ZED-R16 FireWire bus ground connection check procedure.

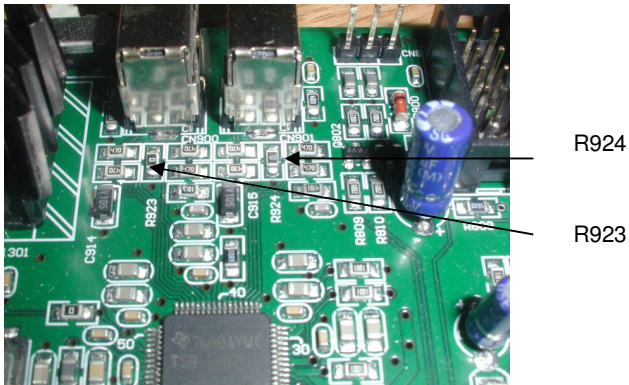
During the manufacturing process of ZED-R16, two 0R link resistors were omitted from a batch of FireWire circuit board assemblies. These links join the FireWire bus ground to the circuit ground and, if missing, there is a chance of intermittent connection between ZED-R16 and the FireWire host machine, resulting in audio dropouts.

- 1) Disconnect all cables from ZED-R16 & turn upside down.
- 2) Remove all the screws from the base panel (T10 head).
- 3) Inspect the FireWire pcb (AG7073) to see if R923 & R924 are fitted or not.
- 4) Also check that the two green wires are fitted to the FireWire board, one to P900 and one to P1310 (SGND).
- 5) If they are fitted then fit base again.
- 6) If missing, contact us and we can either get them fitted for you or let you know what to do. (they can be "blobbed" with solder if you have a soldering iron).

Here is a picture to show where they are:
